MODIFICATION SHEET No. RDSO/ELRS/EL/MS/0389 Rev.'0' Dated
31.08.2010

Provision of additional spring catcher to prevent the main raising spring to fly off in case of breakage of spring of AM-12 or similar design pantographs used on electric locomotives and EMU/MEMU.

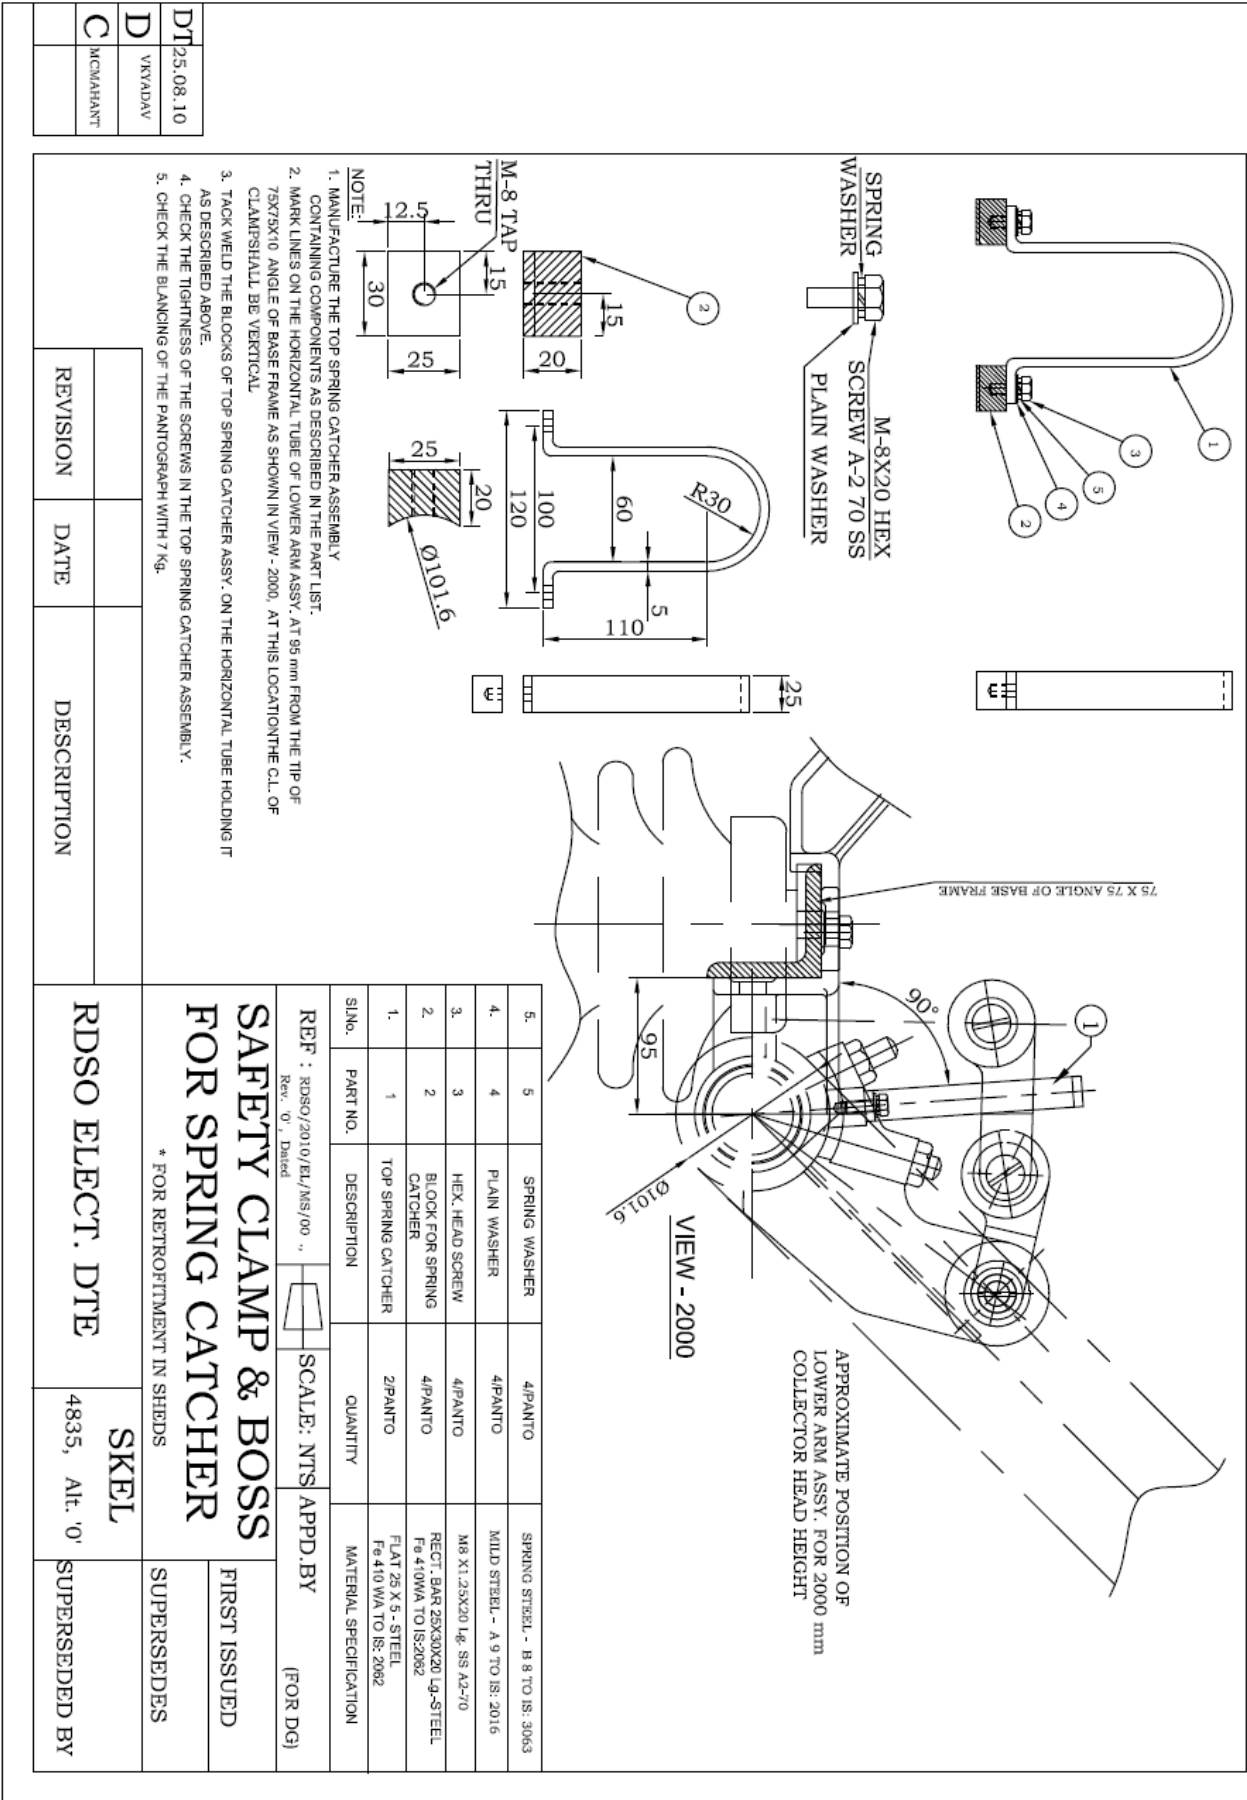
It is observed that in case of breakage of spring near to the anchored location, the contracted length of broken portion is short enough to evade the top spring catchers and it could come and fall on loco roof after springing back.

RDSO have studied the above problem in detail and a modification has been worked out for provision of an additional spring catchers over yoke assembly of main raising spring.

In the event of breakage of main raising spring the modified catchers will not allow to fly off broken spring and it will rest over existing horizontal spring catchers. This will element the line failure due to earth fault by the broken spring.

Provision of addition spring catchers over yoke assembly of main raising spring is to be made as per as per RDSO Drg. No. SKEL 4835 Alt. '0' for the pantographs which are already in service by Electric loco sheds and workshops. The following procedures are to be followed:-

- ❖ The self tapped bushes are to be welded on horizontal tube over the location as shown in the drawing.
- ❖ For fixing the locations of the self tapped bush, raise the pantograph up to 2000mm height and mark lines on the

horizontal tube of lower arm assembly at 95mm from the tip of base frame.

- ❖ Tack welded the tapped bushes at a right angle to the horizontal tube of the lower arm assembly on both side of yoke assembly.
- ❖ Fix the clamp on the tapped bushes and check the operation of the pantograph. Ensure that there will not be any obstruction of pantograph with catcher during full range of operation.
- ❖ After verification of free movement of pantographs carry out continuous welding of tapped bushes.
- ❖ Before welding of the additional catcher above yoke assembly, proper care to be taken during welding of the bushes, Earthing to be made over lower arm not on the base frame to avoid return current not passing through end bearing of the lower arm assembly.

SAFETY CLAMP & BOSS FOR SPRING CATCHER FOR MANUFACTURERS

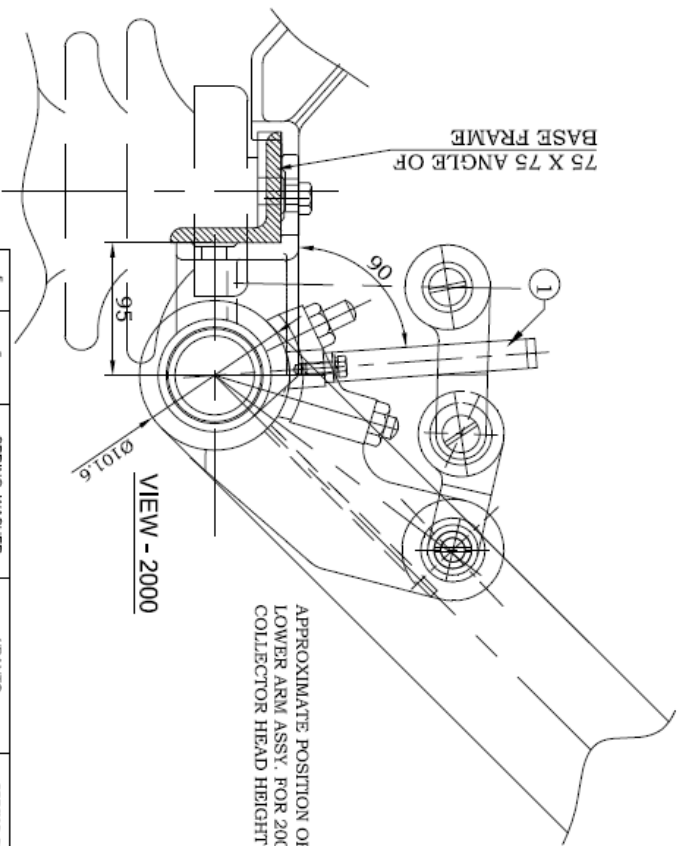
Provision of additional spring catchers over yoke assembly of main raising spring is to be made as per RDSO Drg. No. SKEL-4836 Alt. '0' for the new pantograph by manufacturers.

Drawing No. SKEL-4836 Alt. '0' is for manufacturers for new pantographs as the drilling procedure at shed level may be difficult as it require proper zigs & fixtures for drilling hole on horizontal tube.

1. MANUFACTURE THE TOP SPRING CATCHER ASSEMBLY CONTAINING COMPONENTS AS DESCRIBED IN THE PART LIST.
2. MARK LINES ON THE HORIZONTAL TUBE OF LOWER ARM ASSY. AT 96 mm FROM THE TIP OF 75X75X10 ANGLE OF BASE FRAME AS SHOWN IN VIEW - 2000. AT THIS LOCATION THE C.L. OF CLAMP SHALL BE VERTICAL.
3. TACK WELD THE BLOCKS OF TOP SPRING CATCHER ASSY. ON THE HORIZONTAL TUBE HOLDING IT AS DESCRIBED ABOVE.
4. CHECK THE TIGHTNESS OF THE SCREWS IN THE TOP SPRING CATCHER ASSEMBLY.
5. CHECK THE BLANCHING OF THE PANTOGRAPH WITH Tqg.
